**mcHF Hardware modifications as of September 28, 2015 as compiled
by KA7OEI for the Version 0.3/4 UI and Version 0.4 RF boards**

Step-by-step winding guide for constructing "T5"

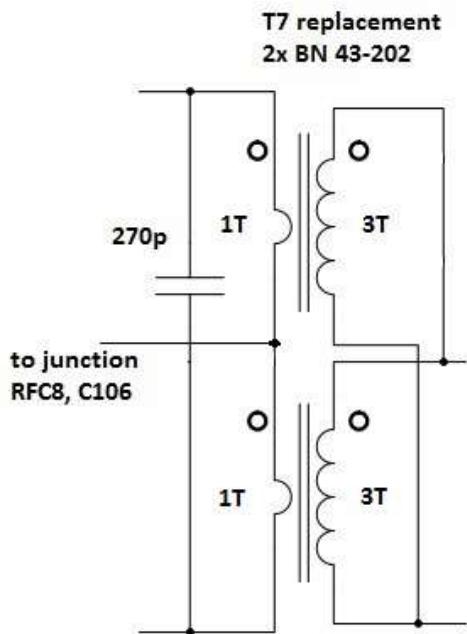
The original part number for transformer T5 on the RF board called for a 1:4(CT) transformer, but a circuit analysis will indicate that this is inappropriate for the impedance of Q4/Q5, the RF Driver transistors. The current BOM calls for a 1:1(CT) transformer – a “less bad” match, but still not ideal in that there is a mismatch causing ripple/loss in the bandpass filters but it is less severe than with the original 1:4 impedance.

A better transformer would be a 4:1(CT) transformer. Unfortunately, one cannot simply turn the original transformer “backwards” since it lacks a centertap on the necessary side in order to properly drive Q4/Q5. Fortunately, it is easy to wind a custom transformer using a BN43-2402 core – the very same core used for RFC8 – and some small-diameter wire.

This reworked transformer is small enough to be soldered to the original pads occupied by T5: Just make the leads as short as practical.

*Details of the constructing, winding and mounting a version of T7, the PA output transformer.
Thanks to Marko, S54AM for these pictures.*

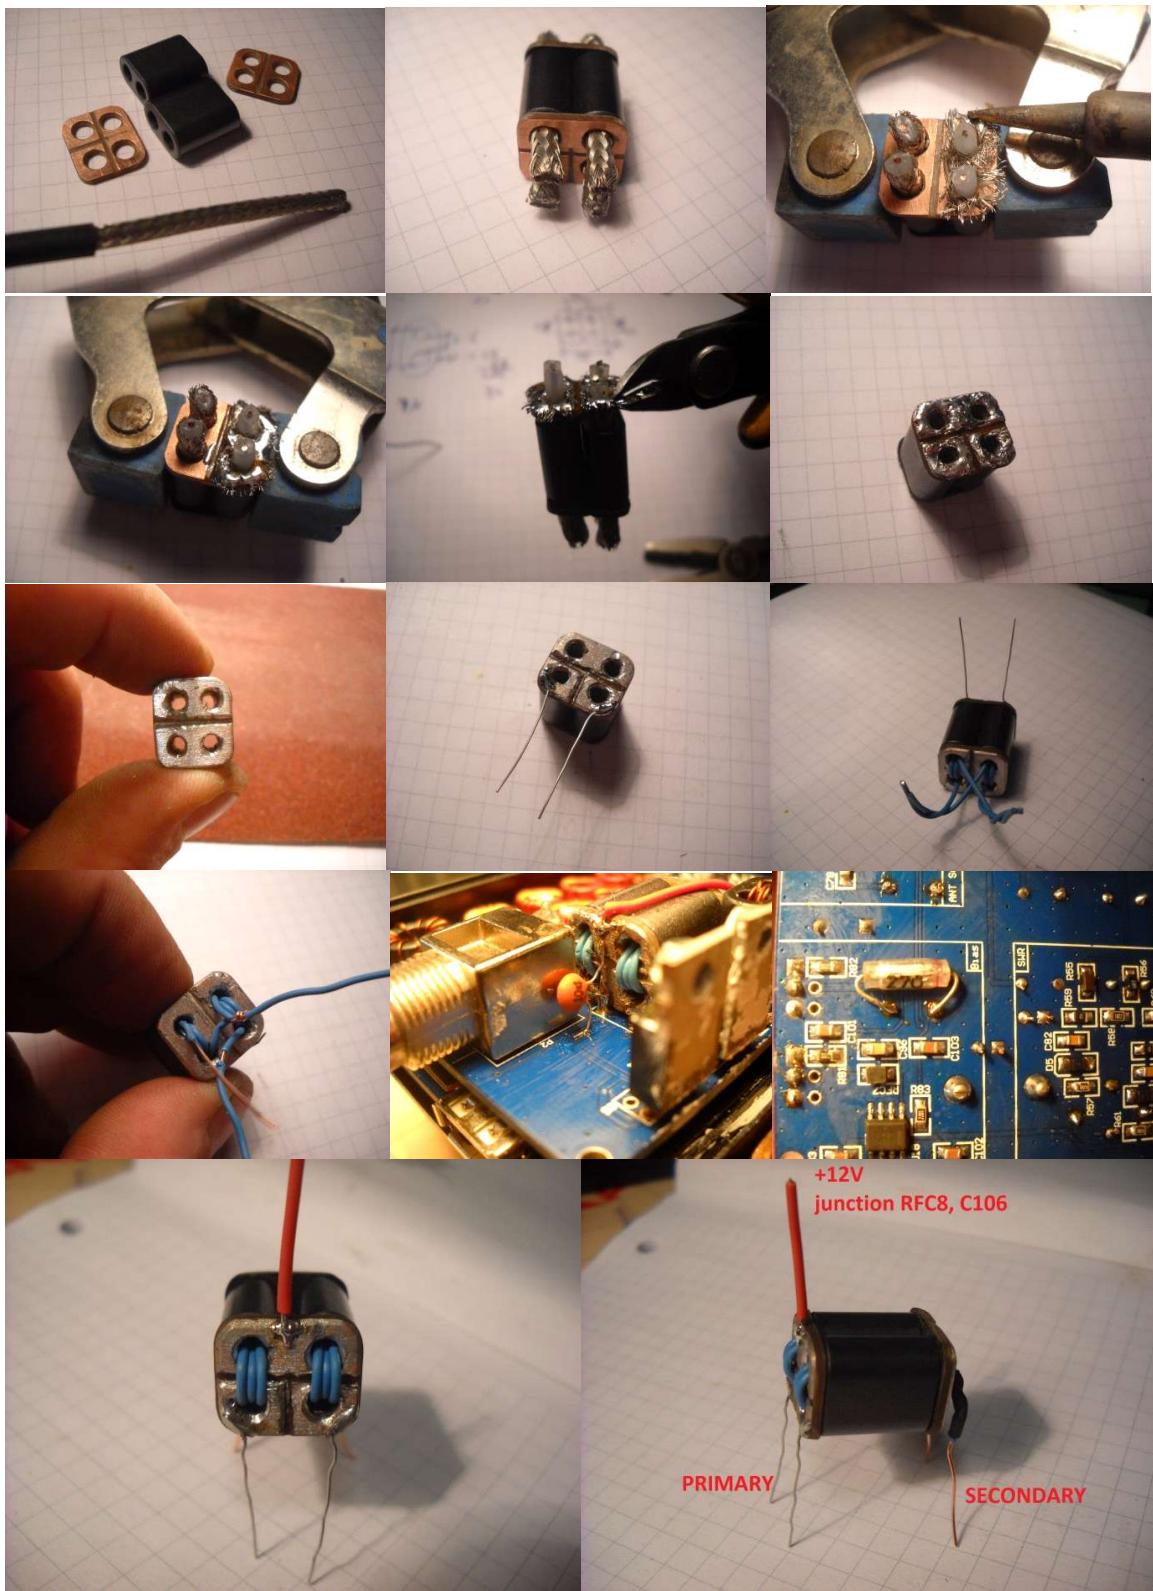
As it turns out there has been quite a bit of discussion related to the ability (or inability) experienced by some users of the mcHF to output a “solid” 5 watts on higher bands. Careful analysis by some of the folks on the Yahoo group has shown that the original transformer design suffers from a few design deficits, namely:

- Primary/Secondary coupling not as tight as it should be
- Excessive leakage inductance
- Transformation ratio not optimal for maximum power output at good efficiency
- Reactance associated with the transformer and other final circuitry is not compensated

As it turns out there are several possible solutions to this problem, all of them using the BN43-202 ferrite core and the solution depicted – one of several proposed – uses **two** of these cores.

It is recommended that the secondary be wound with “Teflon” (PTFE) covered wire if it can be obtained since it is capable of handling high temperatures and its low coefficient of friction makes it easier to wind the transformer.

If one looks closely at the above pictures it can also be seen that on the “center-tapped” side of the primary (the left-hand photograph) a piece of copper-clad printed circuit board is used to connect the primary windings (the coax braid) inside each core together. While this makes for a very neat construction, it is not absolutely necessary, but if flat, copper material – such as PCB material or copper sheeting/flashing – is not used it is recommended that multiple strands of bare, copper wire be used to bond them together.

Finally, although not shown on the schematic – but visible in one of the photographs – it is recommended that a 0.1uF capacitor be connected between ground and where the V+ (red wire in the photograph) is connected on the two cores for optimal RF bypassing.

Preparation of the two small pieces of coaxial cable for the Faraday-shielded "primary" windings.

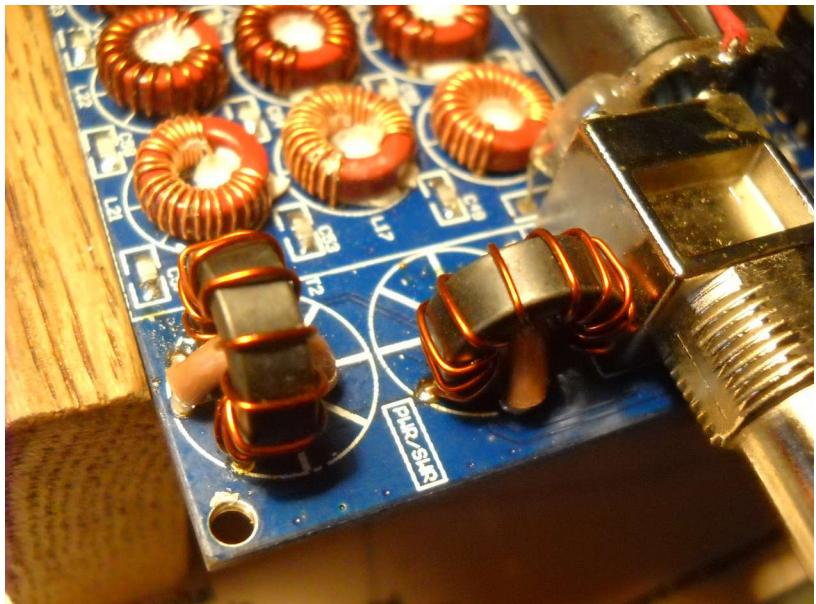
It has been determined that the one-turn “primary” winding should be **Faraday shielded** from the rest of the transformer in order for there to be adequate reverse isolation of the reflectometer to obtain useful readings on the higher bands.

Fortunately, this is quite easily done. Ideally one would use RG-178 coax which is Teflon™ (PTFE)-based, but this coax can be difficult to find, but if one is very careful in soldering the polyethylene-based RG-174 coaxial cable may be used, instead.

The first thing to do is to prepare two, short pieces of coaxial cable as depicted in the left-hand picture, below. Note that on each, the shield is cut off on only one end: The Faraday Shield works by blocking the “E” field radiated from the conductor, but not the “H” (magnetic) field – and it is the “E” field that can cause problems with anomalous, high VSWR readings on the higher bands, even if one is using a known-good dummy load!

Again, it is important to note that the short piece of coaxial cable must have its shield grounded at only **one** side: If both ends of the shield are grounded the "H" field will be suppressed and the transformer will not work at all!

mcHF PA Driver Bias Switching Modification

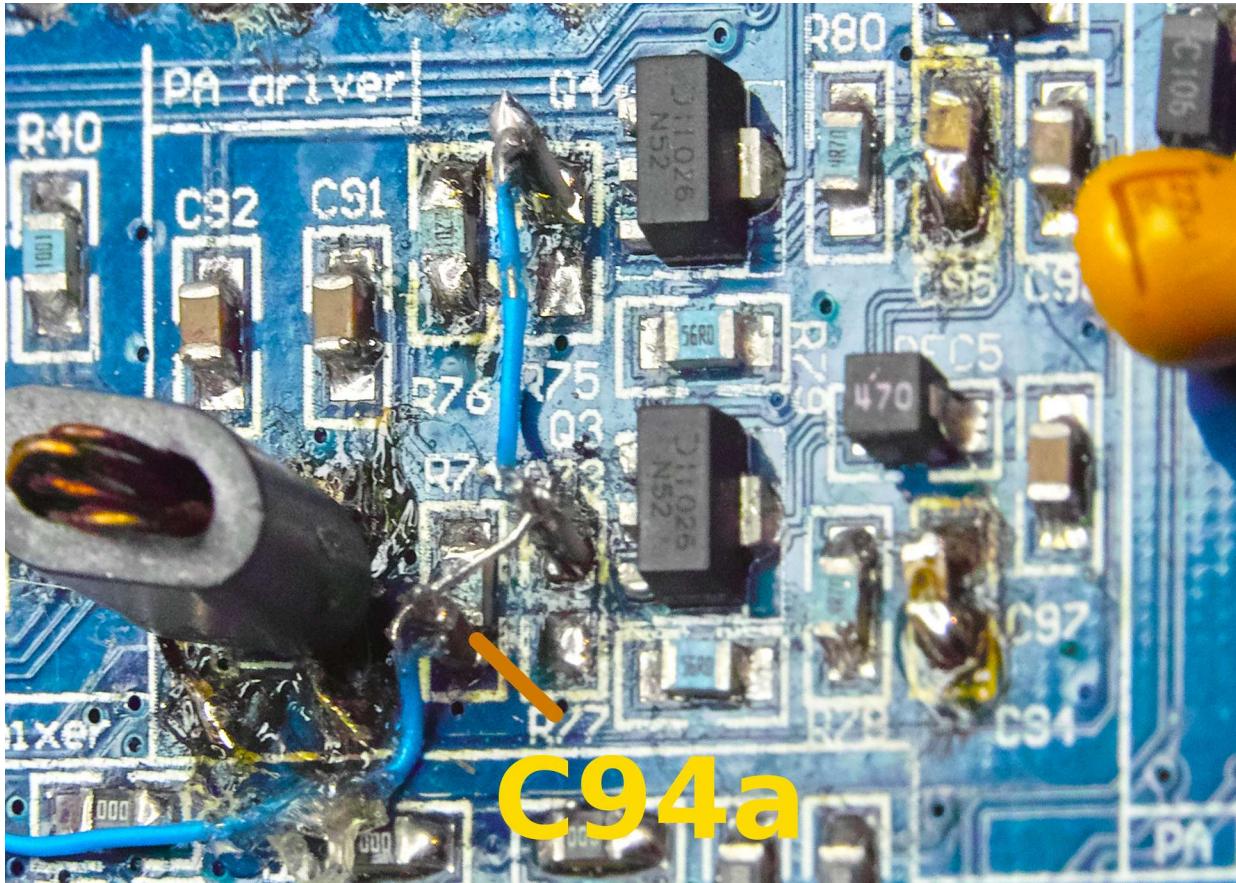
It may be noticed by those studying the diagram – or having happened to make current measurements of the transceiver – that PA driver transistors Q3 and Q4 are *always* biased on. Because of this, an extra 30-60 mA is consumed at *all* times when the power is applied to the transceiver: During receive, and even when it is turned off!

In studying the diagram you will note that bias resistors R73 and R75 are connected, via RFC5/RFC6, to the VCC_12 volt supply – which is always on. R73/R75 also provide a degree of RF degenerative feedback from the collector to the base of the transistors and reduce their impedance as well, possibly causing an increased mismatch to the output of T5, further reducing RF output, particularly at higher frequencies.

It is possible to derive the bias from a regulated source that is switched on when the transceiver is in transmit mode and one such supply of bias is the source of Q1a which provides a *regulated +5* volts (*preferred over an unregulated bias voltage*) when the radio is keyed. Because the bias supply is now 5 volts rather than an unregulated 12 the values of R74/R76 must be changed as well to attain the desired currents.

- Change R74, R76 to 2.2k
- Remove R73, R75
- Where R73, R75 would be, stand on end, in each location, a 2.2k resistor, the bottom end connecting to the base of transistors Q3, Q4.
- Solder, standing on end, 100nF capacitor(s) to the ground end of R74 and/or R76.
- Connect the "top" of these components (the two resistors and the capacitor(s)) together.
- Connect the tops of these components to the junction of R15 and Q1a (at R15) using a piece of very thin, insulated wire: I used #30 AWG wire-wrap wire, tacked down in several places with small dots of thermoset ("hot-melt") glue.

Additional comments about this modification – how it is done in the newer board:

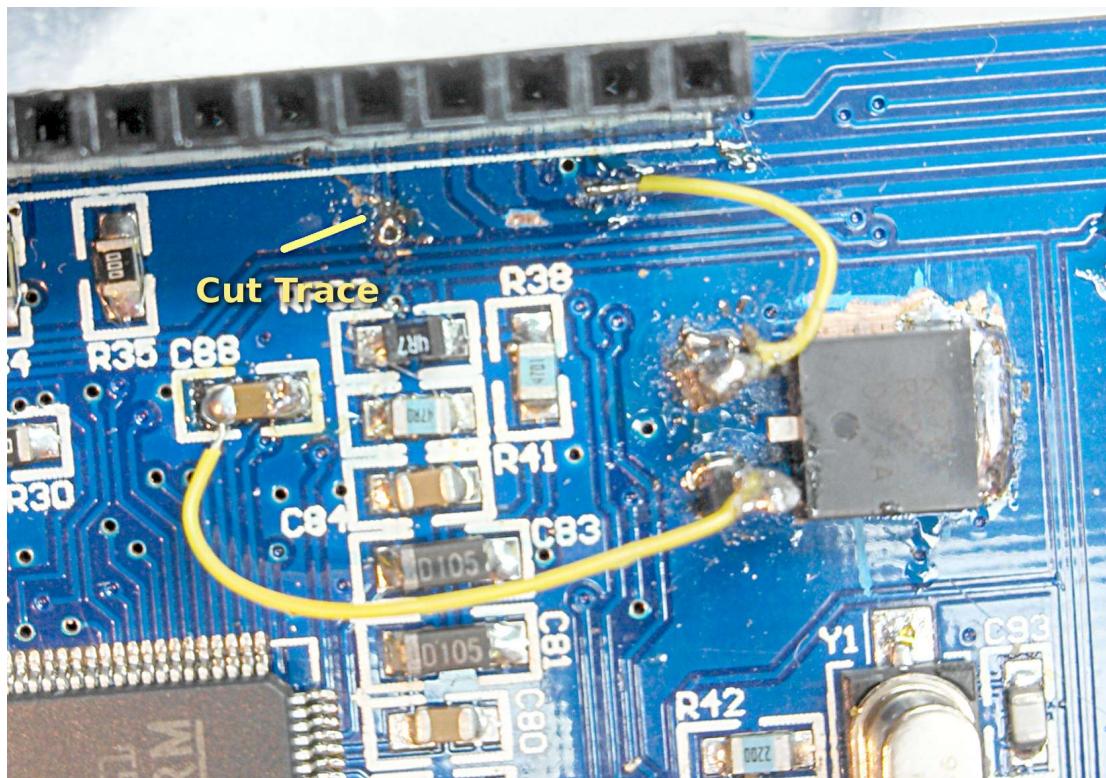
The newer version of the UI board (version 0.4) has *additional* filtering beyond that mentioned above in that it uses **two** resistors and **two** capacitors for filtering. In addition to the existing capacitor at C32 and the added resistor mentioned above, there is yet another capacitor to ground and series resistor: Both of these series resistors are 2.2-2.7 ohms and the capacitors are at least 220uF in capacitance.

These two capacitors and resistor together provide somewhat better filtering than a single capacitor/resistor.

Diagram depicting the MCU's own, isolated 3.3 volt power supply. This also shows additional isolation of the LCD power supply as well as the suggested, separate 5 volt power supply for the UI board - see text.

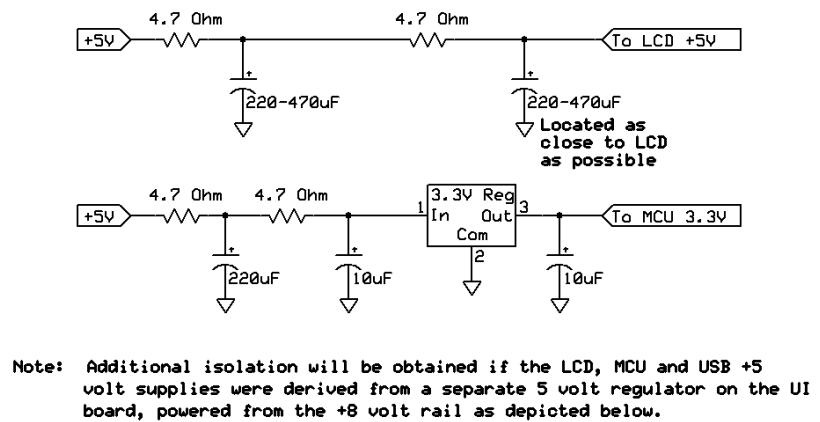
It was noted that when the above modification was completed that there was residual noise on the 5 volt line so further investigation was carried out. It turned out that the remainder of the noise was from two sources:

- The +5 volt supply for the LCD
- The transmission of noise **through** the 3.3 volt regulator.

When the “LCD Backlight Brightness” control function was added, the need for even better filtering of the LCD's power supply was made apparent as the modulation of the LCD's power supply current rippled (literally!) throughout the rest of the receiver!

For LCD filtering, place the noted capacitor as close to the LCD's pins as possible – preferably *at* the LCD itself! The 4.7 ohm resistors and the other capacitor may be placed farther away, but the second capacitor should be placed as close to the LCD's ground as well.

On the 3.3 volt MCU regulator, the 220uF capacitor on the input side of the 3.3 volt regulator, along with the 4.7 ohm resistors, form a low-pass filter that provides an impedance path between the noise source at the input of the regulator and the capacitor, greatly improving its ability to filter. The other 4.7 ohm resistor provides isolation between the noise that remains at the 220 uF capacitor and the rest of the 5 volt bus in the transceiver.

This picture shows the location of the traces and where the cuts should be made. This is found to the right and above U4a, the MCU. A picture of a “bare” board is used for clarity.

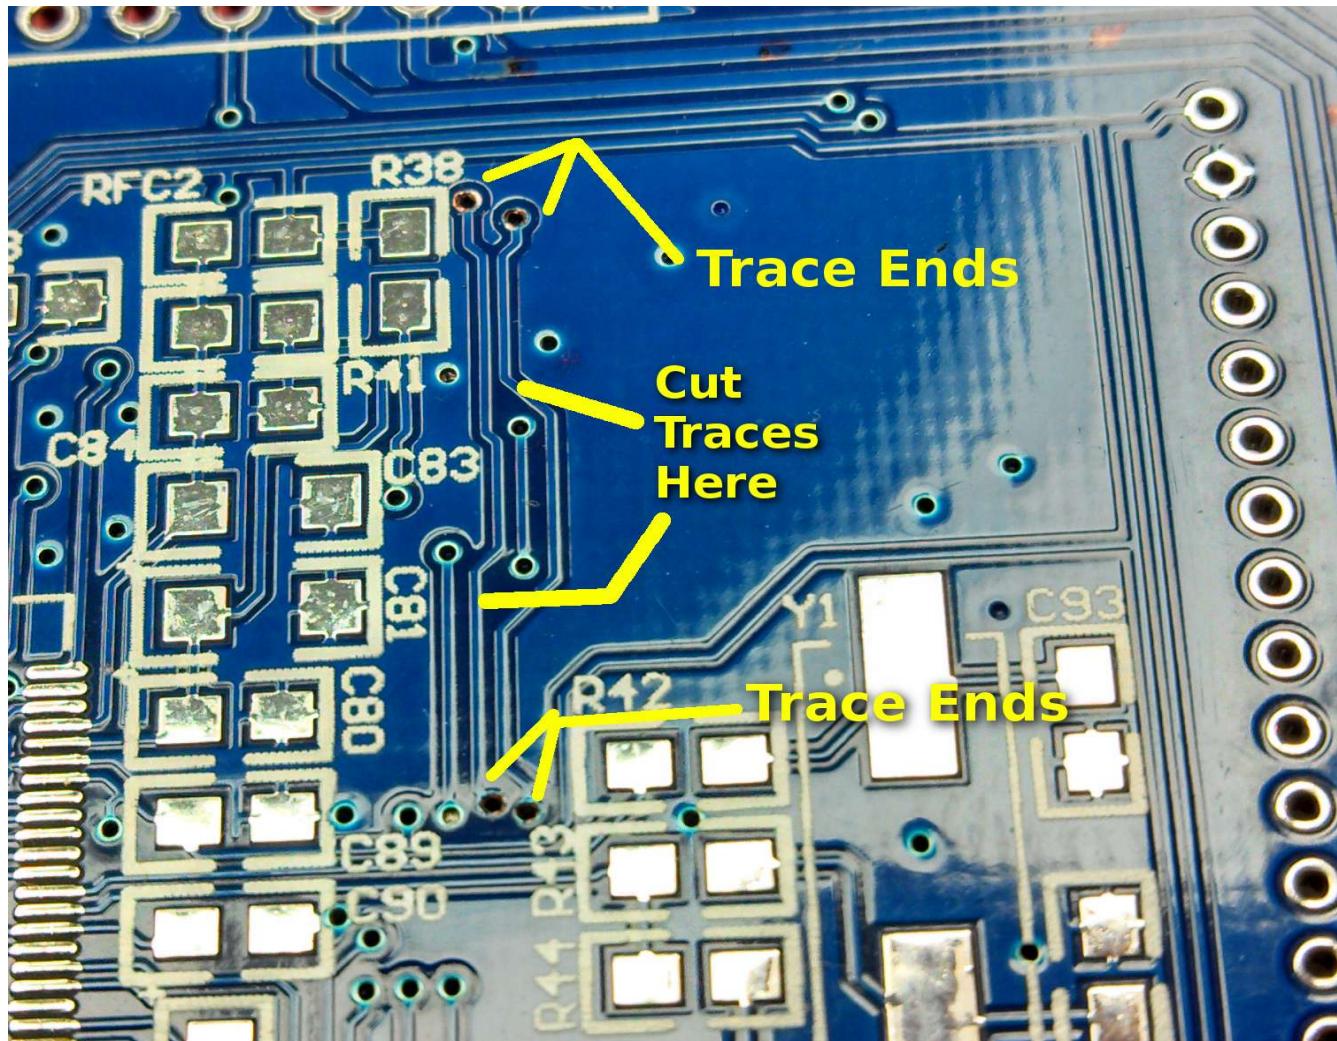
If the above modifications are made, with no antenna connected – or even with an antenna connected when listening on higher bands (especially 20 meters and above) a fairly strong “tick” may be heard every second. This is due to the polling of the onboard temperature sensor and the fact that the “fall” time of the on the I2C line from the MCU is extremely fast and rich with harmonic energy. This problem can be easily “fixed” with the addition of resistors on the UI board in series with the SCL and SDA lines which effectively reduce the slew rate of these lines, quashing the RF energy.

A reasonable value of resistor to install is 470 ohms and the installed components may be seen in the picture.

Of the rise and fall times on the I2C, the slowest slew rate was the rise time shown in this digital oscilloscope capture, which is well within the acceptable time for the clocking rate!

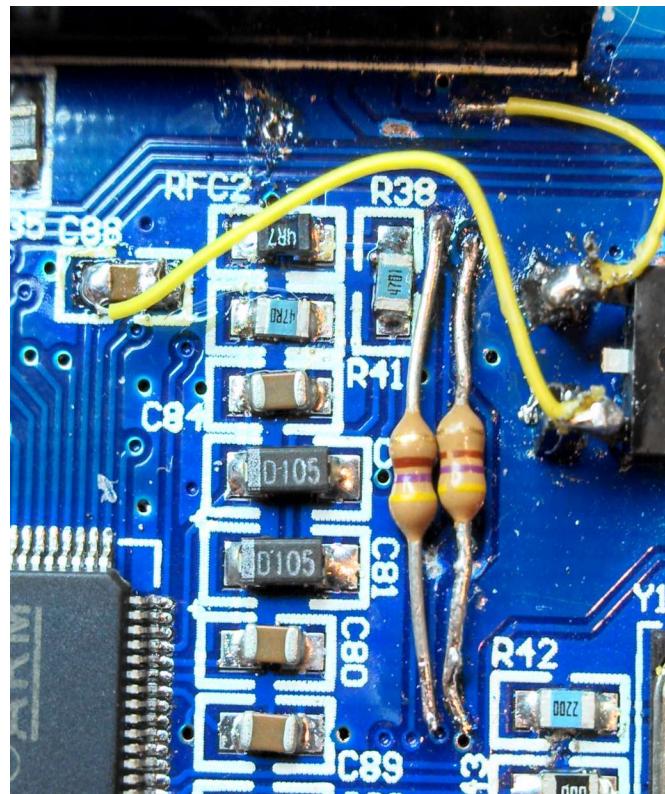
To verify the integrity of the I2C data stream – which is shared with the Si570 frequency synthesizer – I monitored the data stream with a digital storage oscilloscope and measured the worst-case slew rate – which was actually the risetime - the result being noted below.

As can be seen, the risetime is less than 740 ns at the 10%-90% points which is a fraction of the I2C clocking rate, well within the time at which the edge of the clock into which the data is strobed in by the peripheral.

The added 470 ohm resistors in series with the SCL and SDA lines. Note that this picture also shows the added 3.3 volt MCU regulator mentioned above. 1/8 watt, leaded resistors are used, but surface mount resistors could be used, if

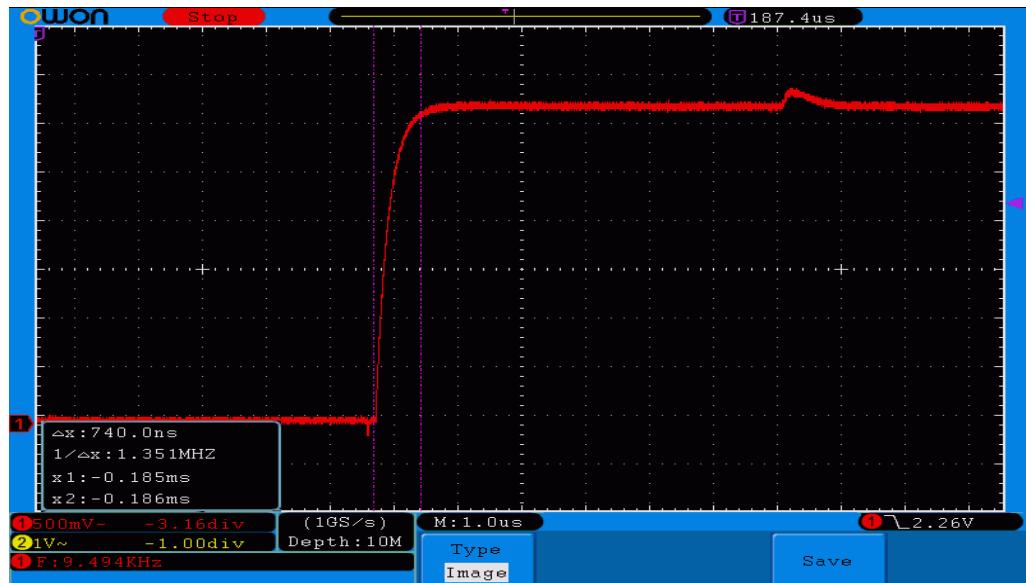
In the picture can be seen the two added 470 ohm resistors. As you can see, I used leaded 1/8 watt

resistors, but surface mount resistors can be used, instead if that is your preference. (The 3.3 volt regulator used for the MCU – see the modification earlier in this document – can be partially seen.)
